CCK-2874.00-3-25 New Environmental Quality Management Center BP02 ADDENDUM #1 05/01/2025

## ADDENDUM #1

project UK Environmental Quality Management Center

**IC1.**<sup>4</sup>

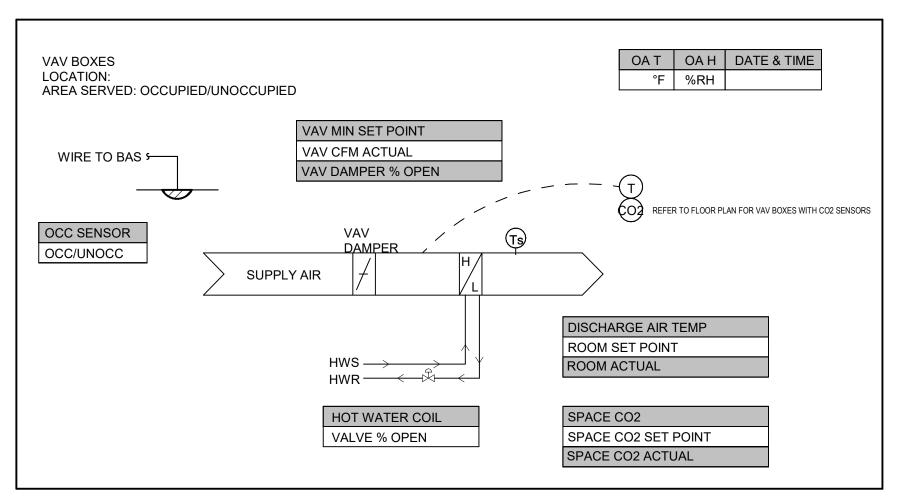
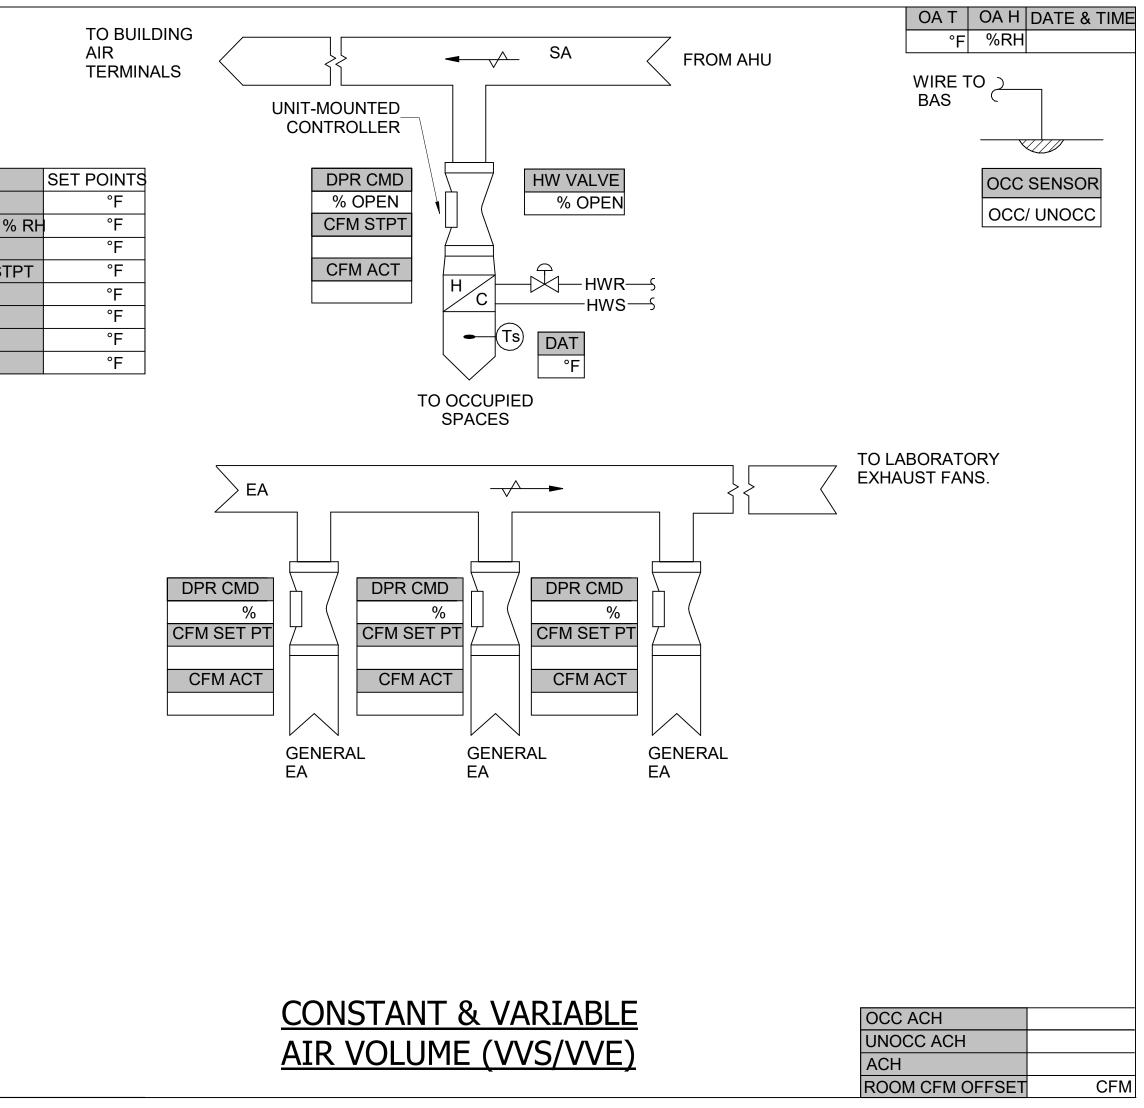
- Item #2 Refer to sheet M7.1 MECHANICAL DETAILS
- A. See added detail, "FIRE DAMPER DETAIL."
- Item #3 Refer to sheet IC1.1 CONTROL DIAGRAMS
  - A. Upon receiving a signal from the fire alarm system, the control valves Lab H103E and H103F shall close. A manual switch shall be provided in the second floor mechanical room next to the CO2 tanks that will tell the valves to open and allow exhaust to evacuate the air in the space.

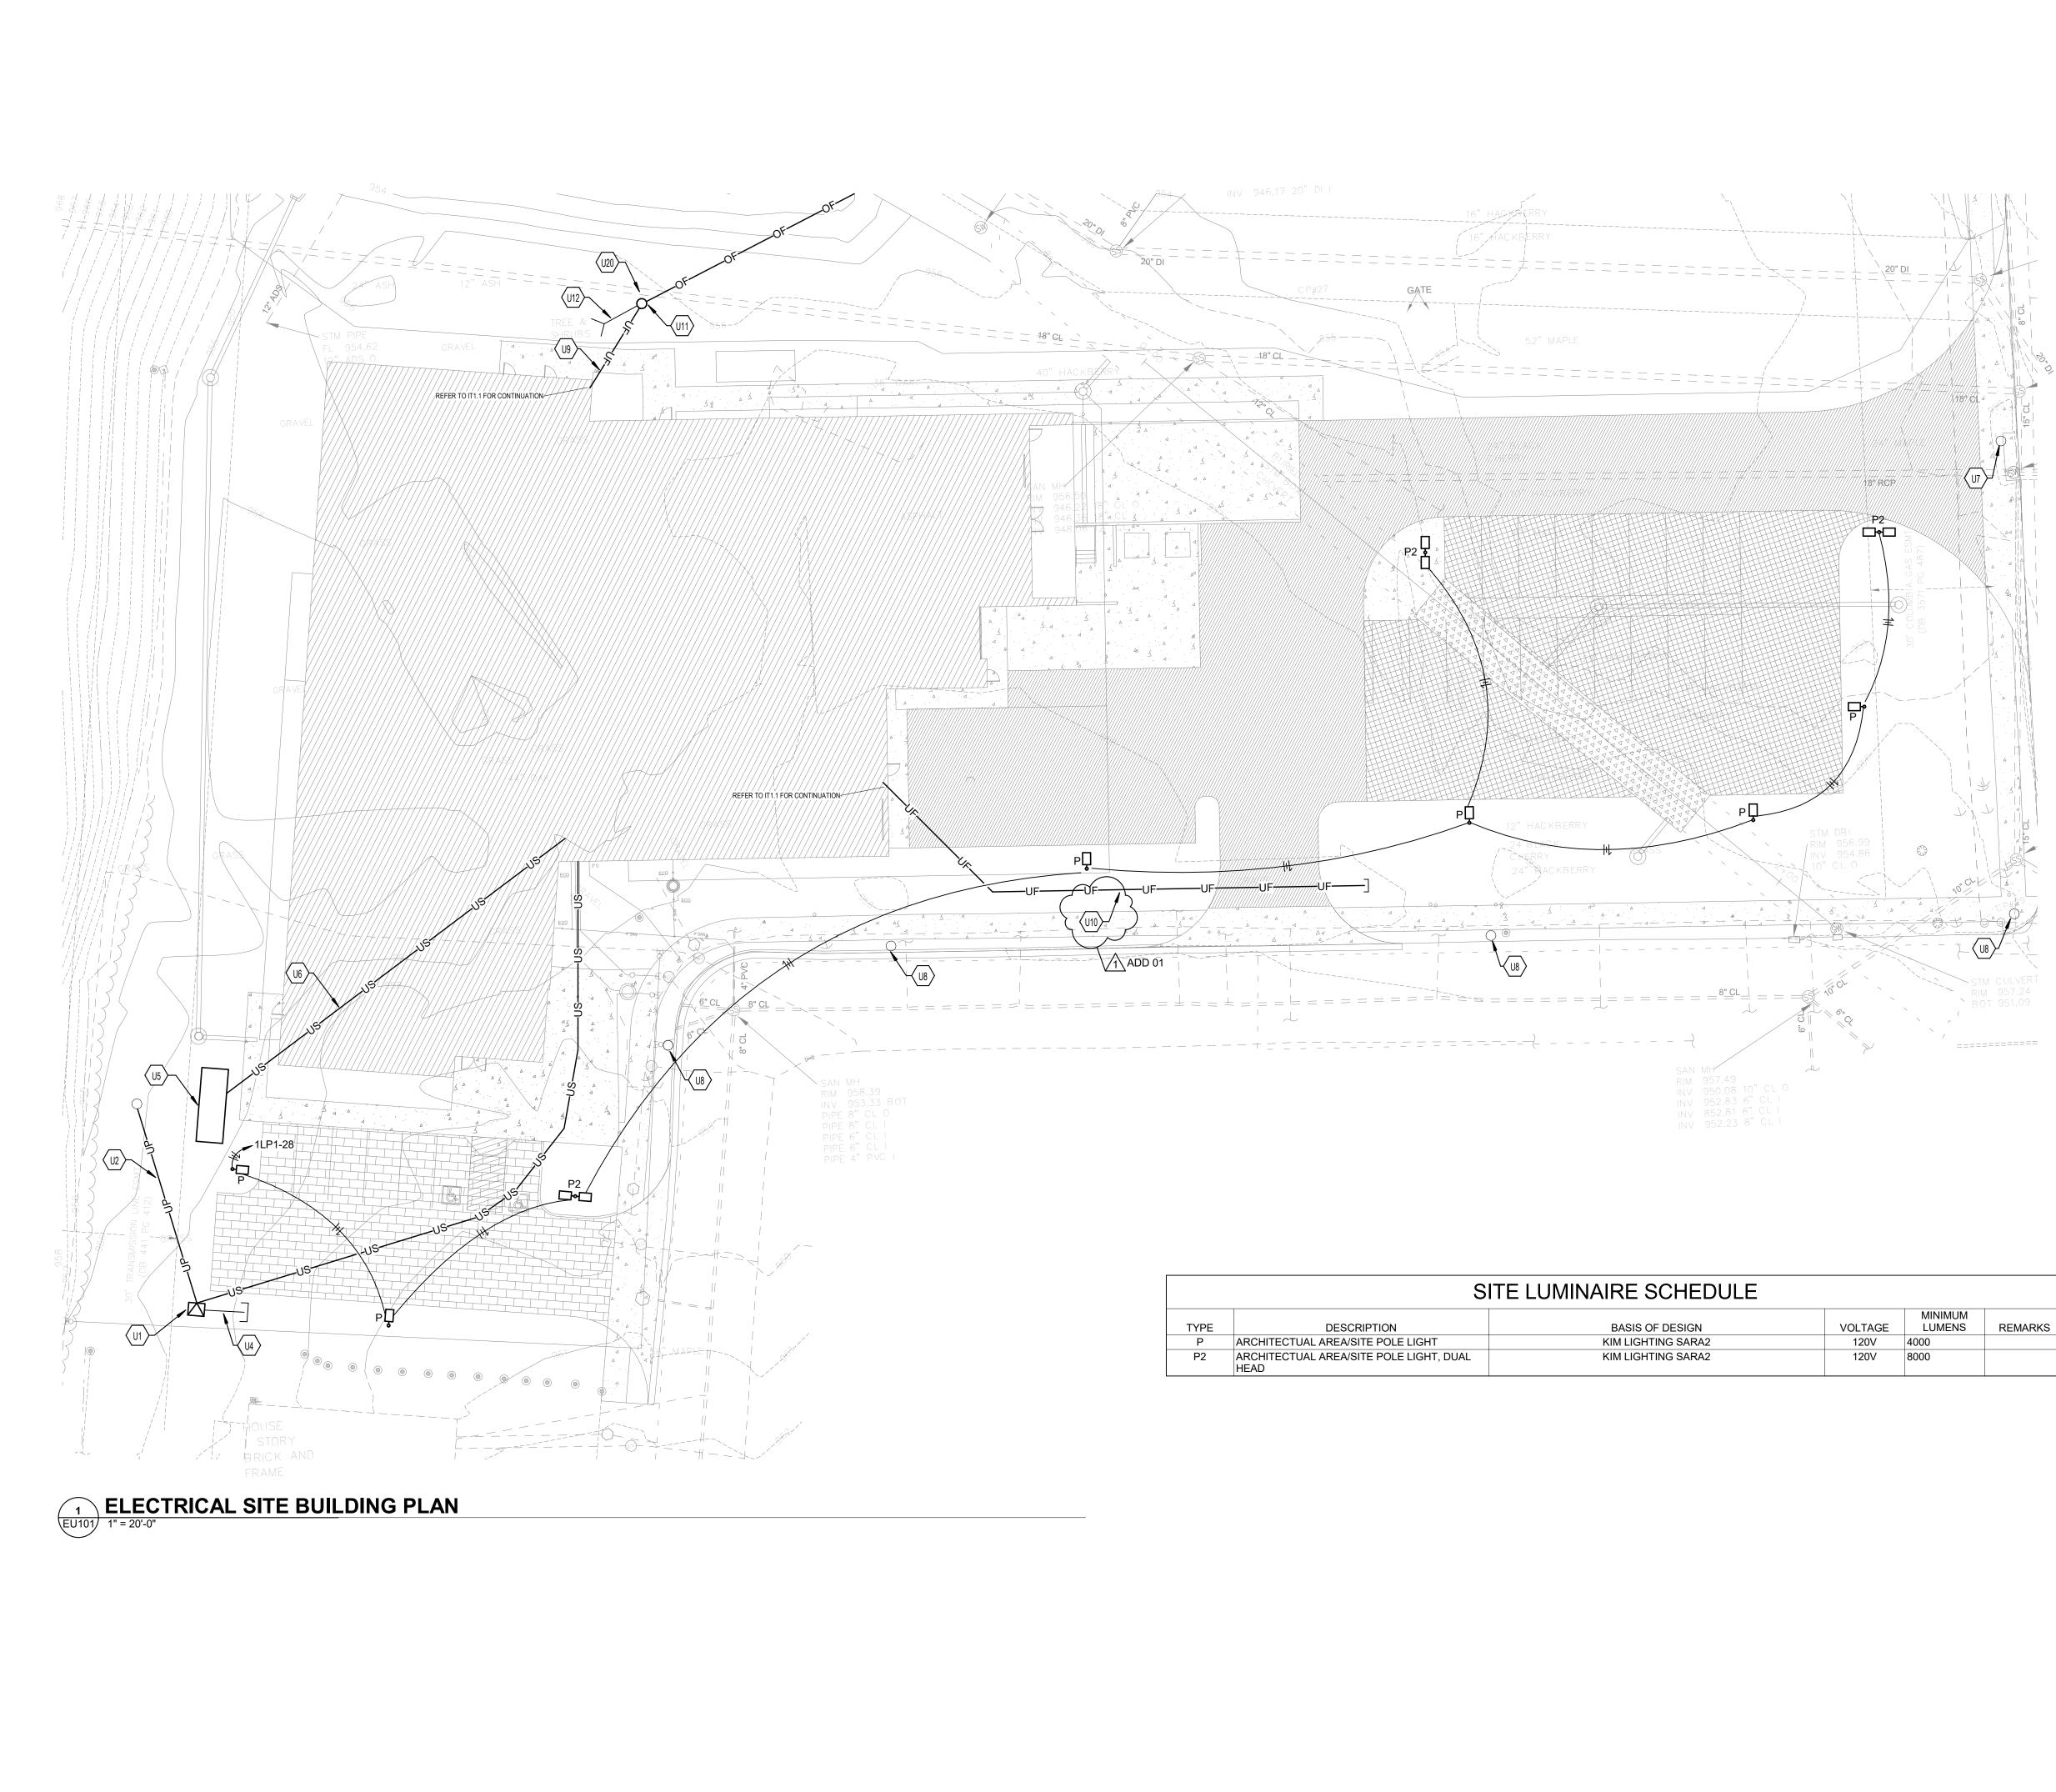
- Item #4 Refer to sheet EU101 ELECTRICAL SITE UTILITY PLAN
  - A. Moved tagged note U10 to the correct location to refer to the underground fiber line.

**FIRST FLOOR LIGHTING PLAN**

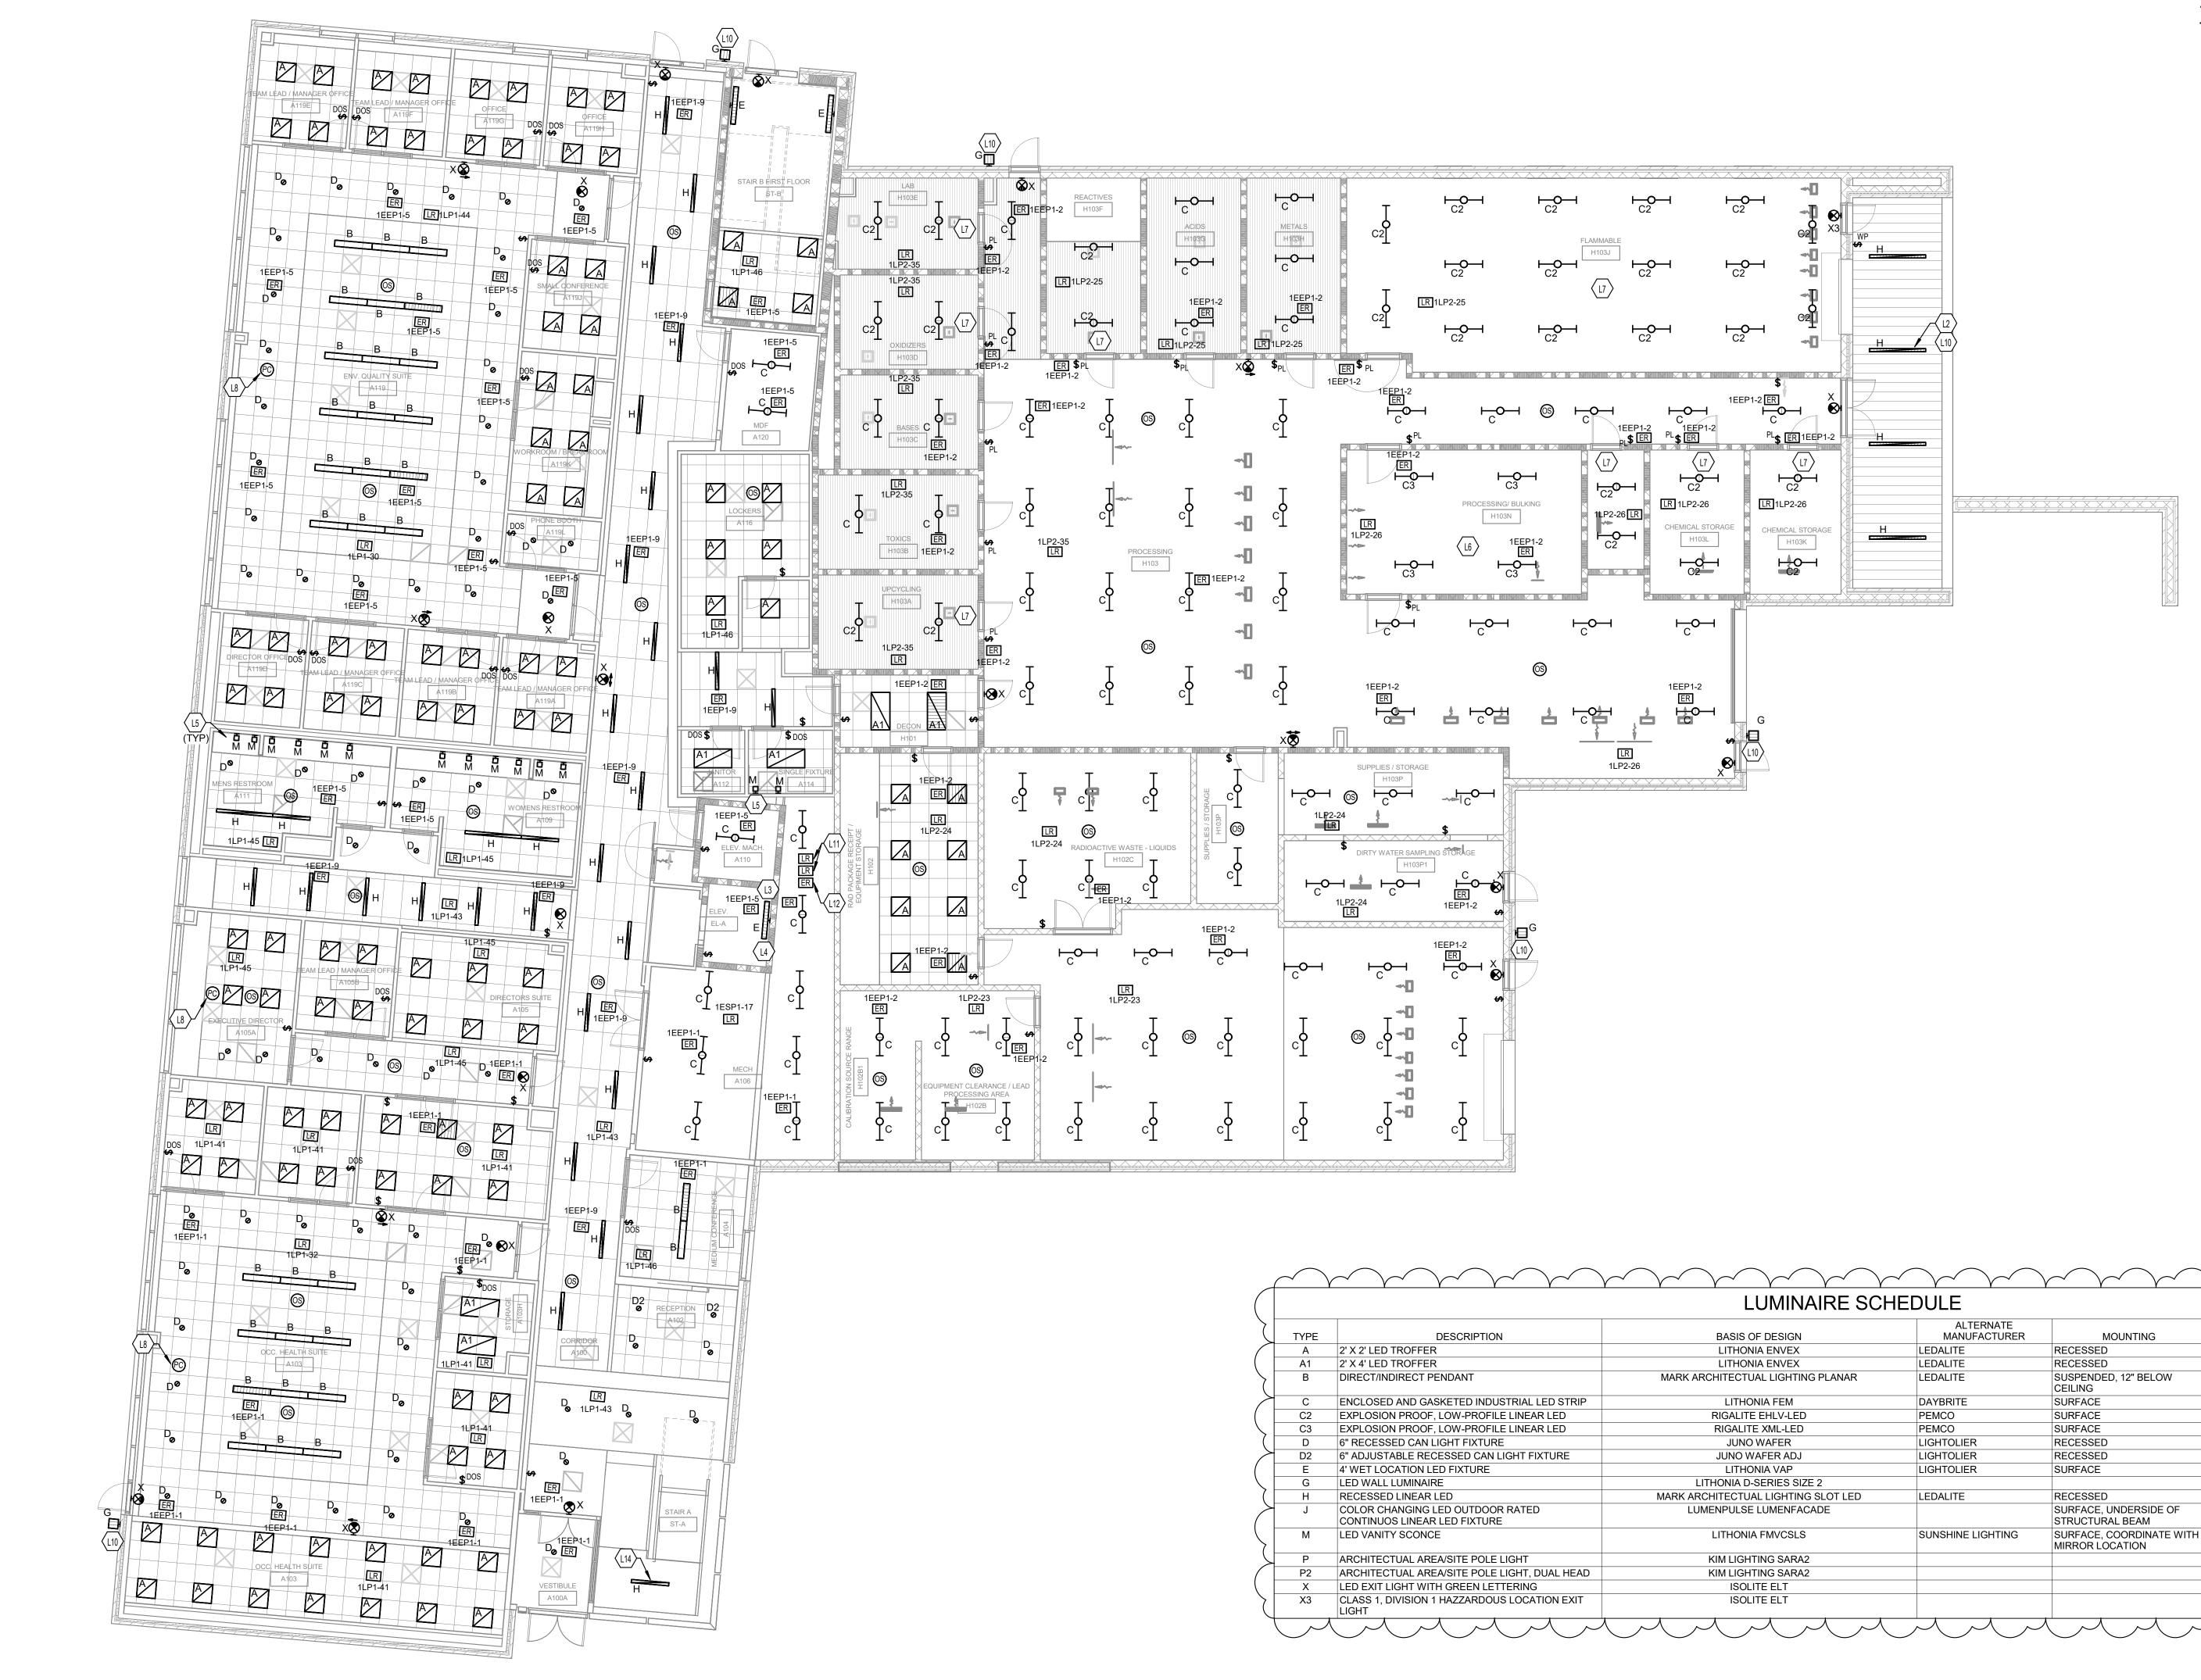
- B. Edited notes U5 and U6 to include data outlet for BACNET integration of generator.
- Item #5 Refer to sheet E2.0 FIRST FLOOR LIGHTING PLAN
  - A. Edited luminaire schedule to include columns for Alternate Manufacturer and Mounting.
